1MC05 - HS2 MWCC - C1 - Chiltern Tunnels and Colne Valley Viaduct

Colne Valley Viaduct Groundworks South – Savay Lake Maintenance Access Road and Anglers’ Car Park

Written Statement

Document no: 1MC05-ALJ-TP-REP-CS01_CL01-001054

Figure 5-2: Resubmission Design including Anglers' Car Parking Area

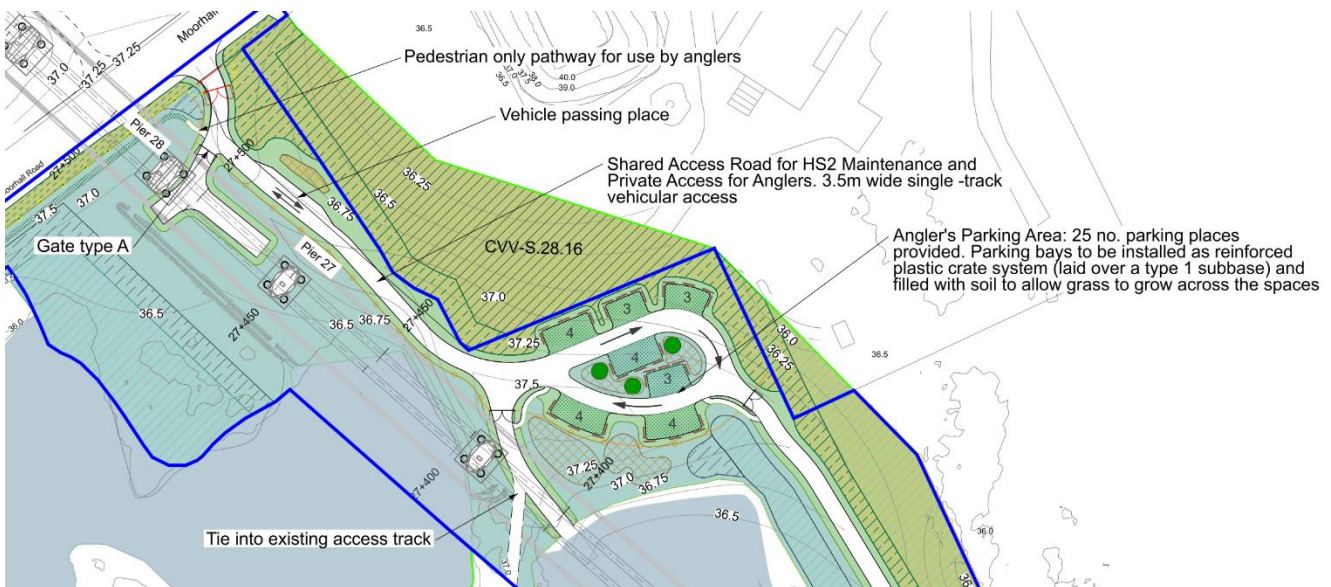
- 5.2.2 This resubmission (Shown in Figure 5-2) seeks to modify the maintenance access track to provide a car parking area for anglers at Savay Lake, equivalent to the pre-existing informal car parking in-situ prior to the commencement of HS2 works, together with a pedestrian access route to allow fisheries visitors access to swims along Savay Lake.

- 5.2.3 The car park would allow for 25no. car parking spaces.
- 5.2.4 The intention is to create informal car parking bays within wider planting to help integrate the facility within a more naturalized environment. The circular route allows access to all parking areas whilst providing an easy turning and site exit route. It also maintains clear passage along the HS2 maintenance access route.

- 5.2.5 Car parking bays would comprise a reinforced plastic crate system (laid over a type 1 subbase) and filled with soil to allow grass to grow across the spaces. This will ensure a more natural finish and overall improvement to the visual impact, whilst having no affect on surface water drainage.

- 5.2.6 The bays would be edged with timber logs to define the extent of the surface reinforcement area, helping to reduce informal parking on potentially soft ground.

- 5.2.7 The single width (3.5m wide) access track would allow access to the car park with laybys to allow passing, minimising hard landscaping within site as far as practicable.

- 5.2.8 Access to the car parking area would be from Moorhall Road. The entranceway would include swing-open 'top-bar' which will allow entry to users of the fishery and be operational by HS2 when required.
